City of Lake Elmo

NOTICE OF MEETING

**LAKE ELMO PLANNING COMMISSION
STAFF REPORT**

**LAKE ELMO PLANNING COMMISSION
STAFF REPORT**

EXTERIOR ELEVATIONS

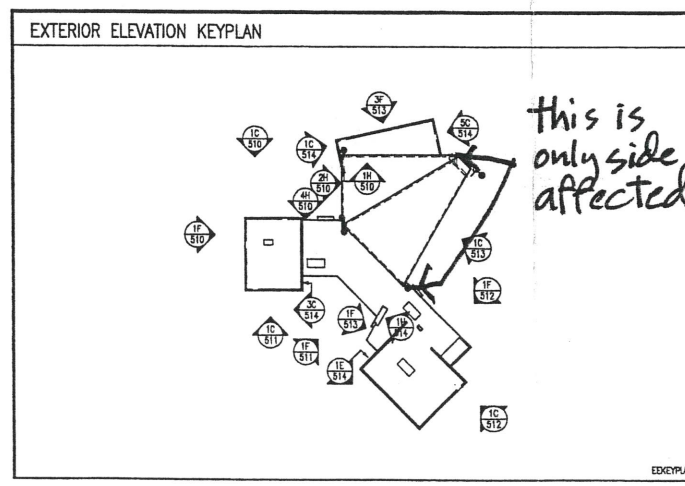
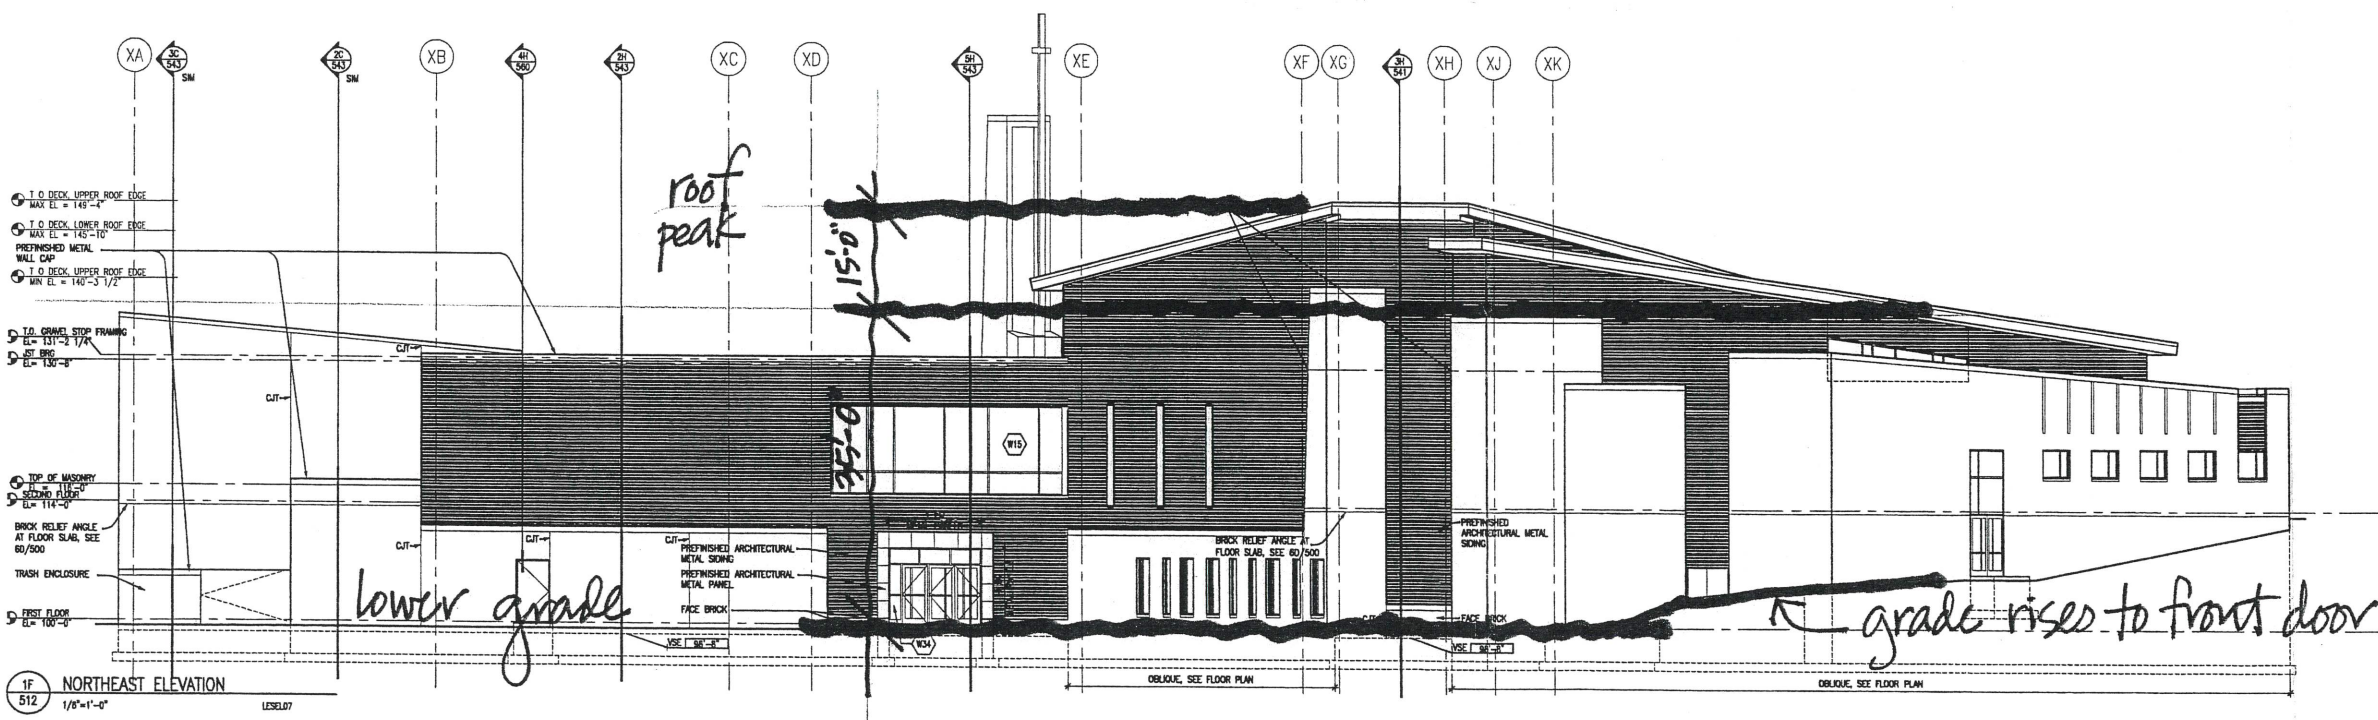
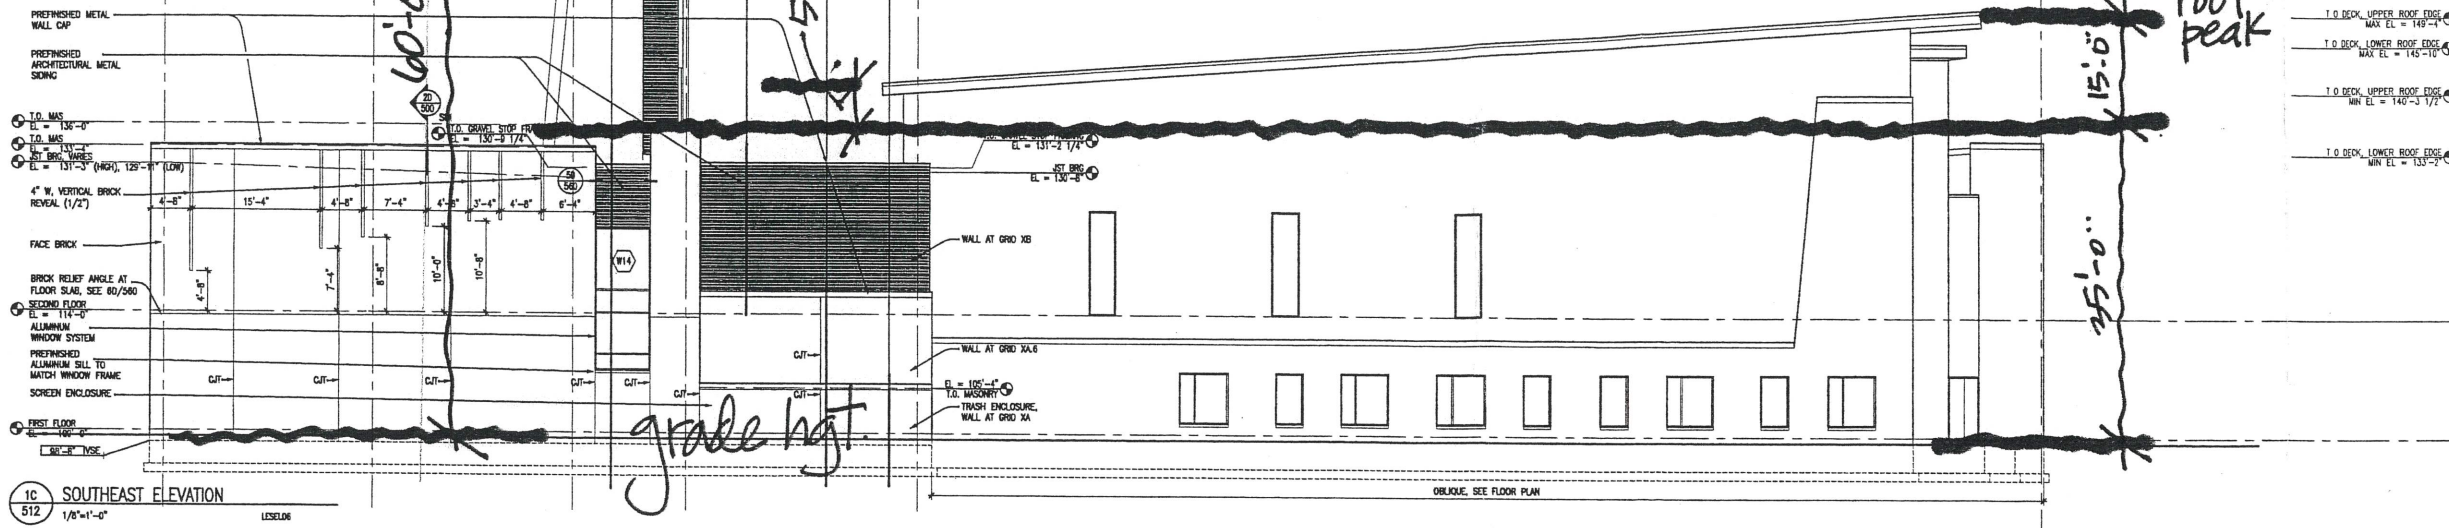
Assuming the foregoing, the only remaining variance is that for sidewall height. The PF standard for sidewall height is 35 feet. The Rockpoint site plan proposes a widely varying sidewall height (depending on where and which side of the building is measured). There are locations where the sidewall height ranges up to 49 feet. By a March 29, 2006 letter from the Rockpoint architects (BWBR) the applicant has presented its case for hardship based primarily on the physical characteristics of the site.

side wall surface area ranges from
5'-0" to 15'-0" over ordinance.

Motion to recommend approval of a variance for the Rockpoint Church to allow sidewalls of the structure to extend to a maximum of 49 feet based on the Findings of the Planning Staff Report of April 20, 2006, and per plans staff dated April 20, 2006.

1C 511 SOUTH ELEVATION
1/8\"/>

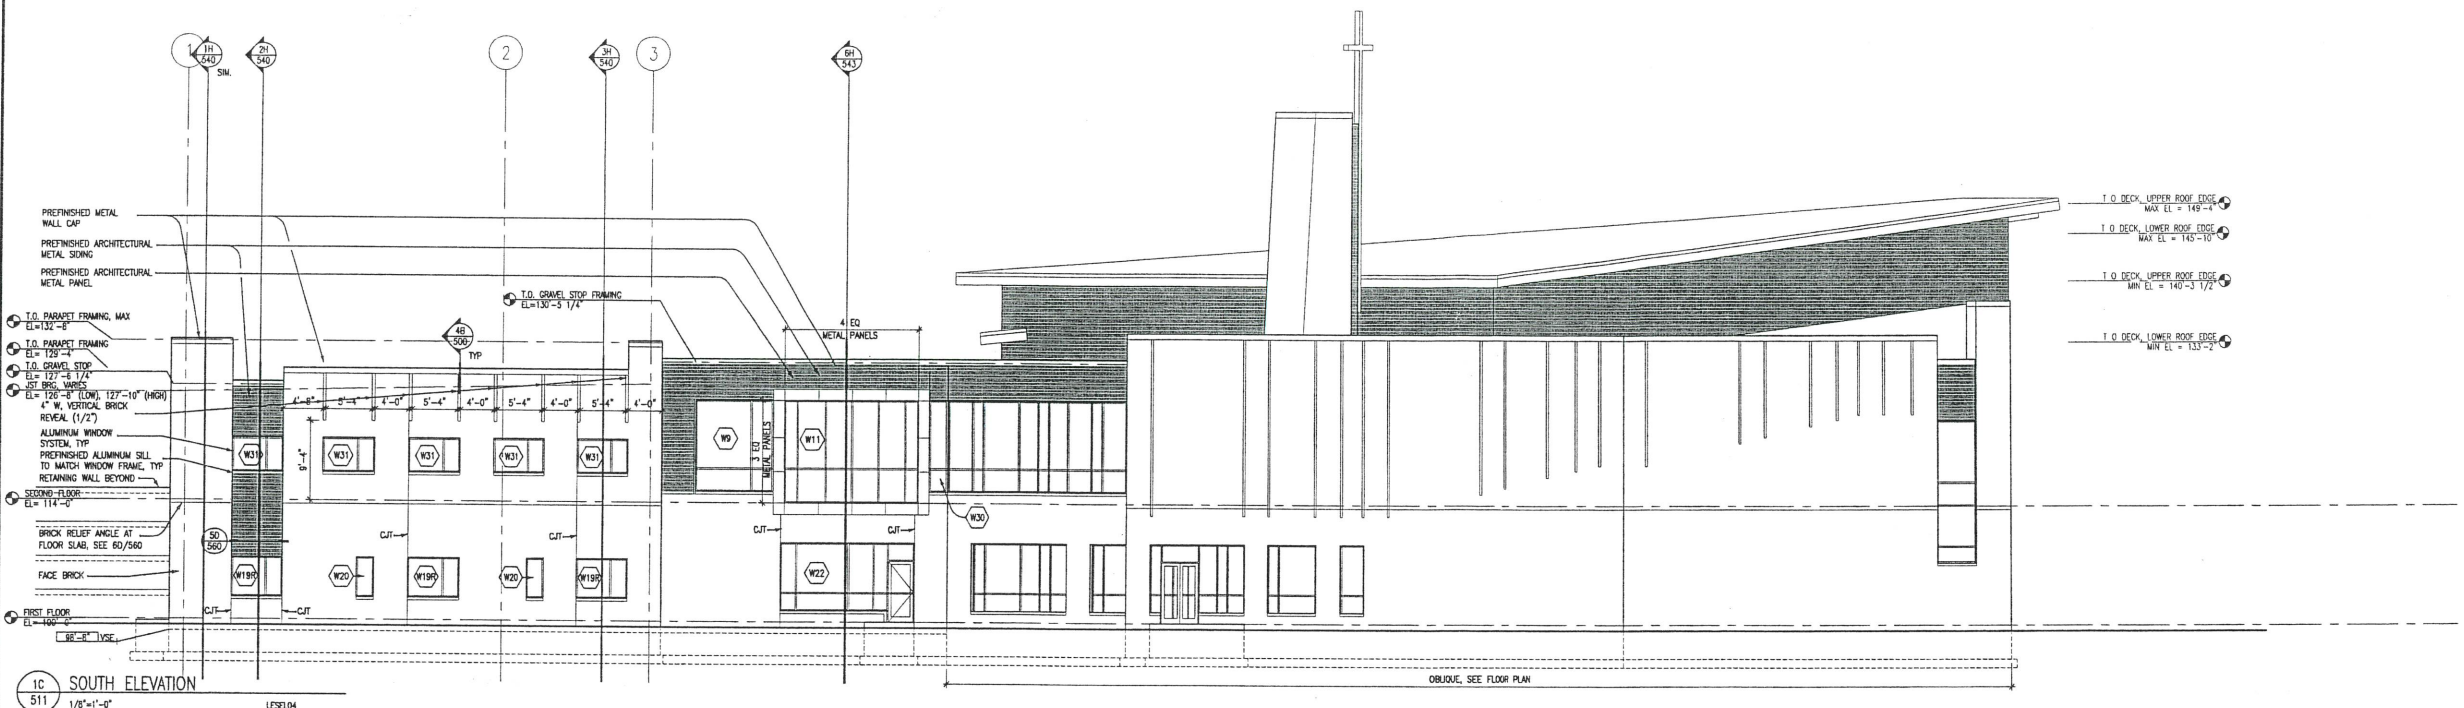
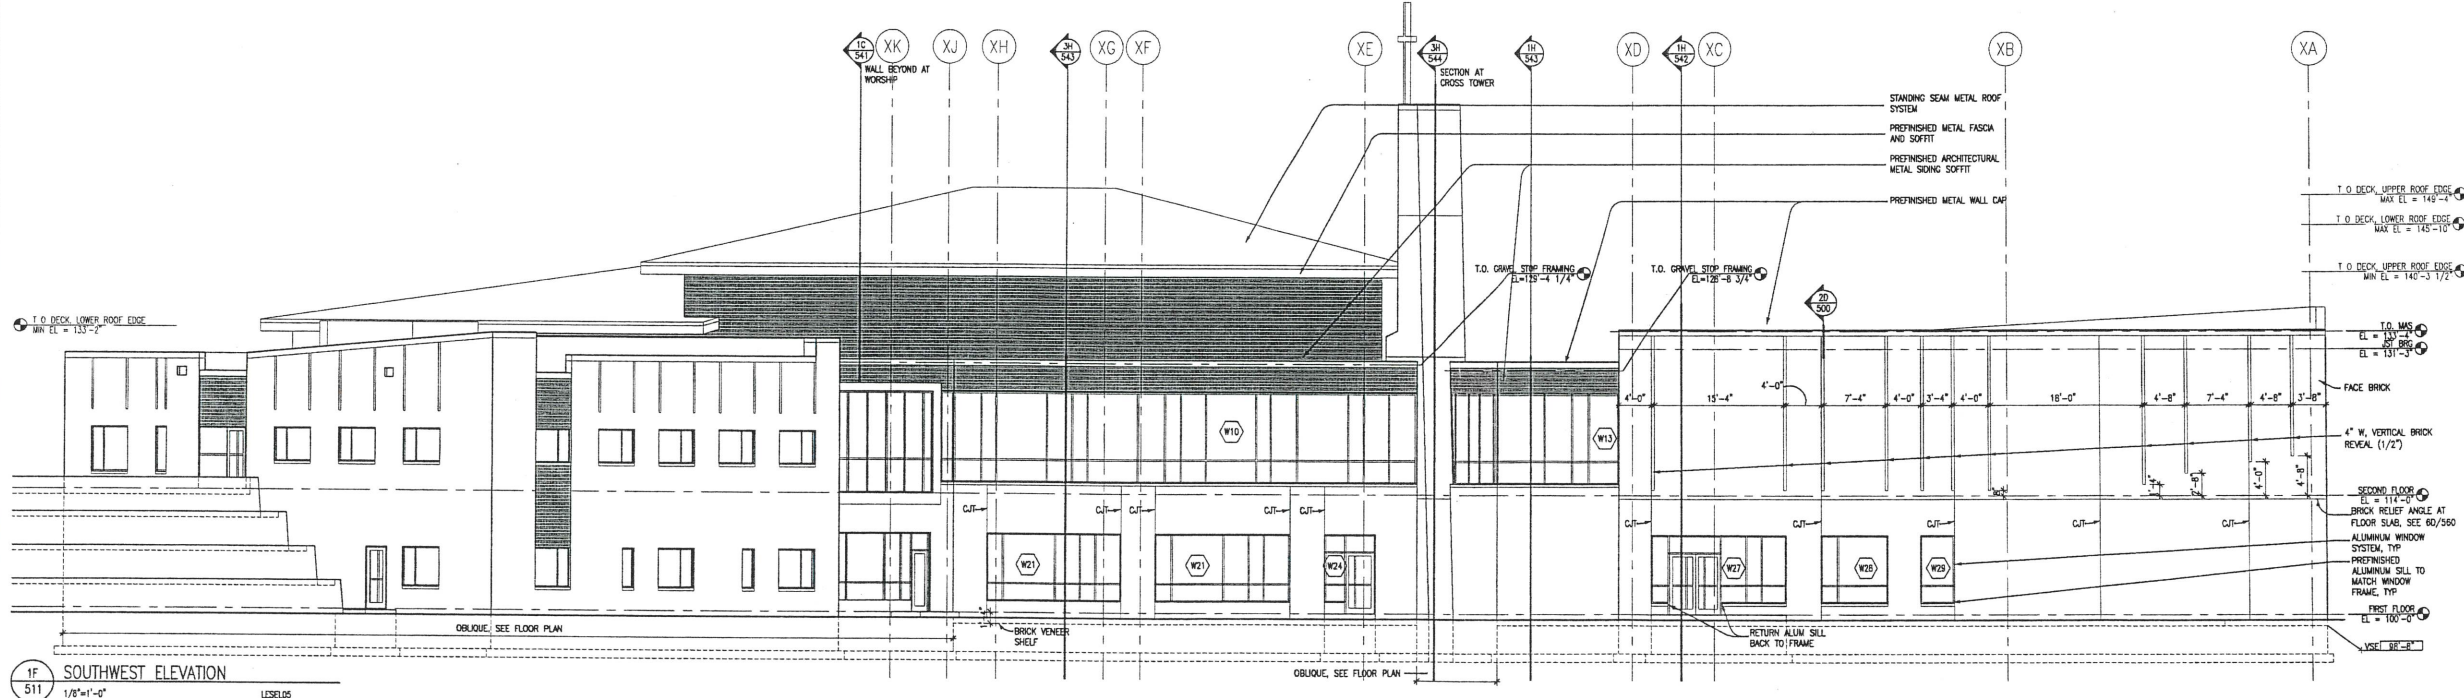
- Item No. 5: The structural side wall on the southeast exterior wall of the church exceeds 35' in height. The wall in question has a sloping roof edge varying from 40' to 49' above grade (see elevation 1C/513, Partial Exterior Elevation). We hereby request a variance to allow this condition to exceed the 35' maximum in this location considering the following reasons:

5. PF standards provide for a maximum building height of 50 feet., but no structure side wall exceeding 35 feet in height. With measurement of building height on a pitched roof taken from the mid point of the pitch slope it appears that the roof height of the structure complies with the 50 foot standard. However, it also appears that that structure side walls exceed the 35 foot maximum height at several locations – in some places nearly 50 feet. Either s redesign or a variance would be required.
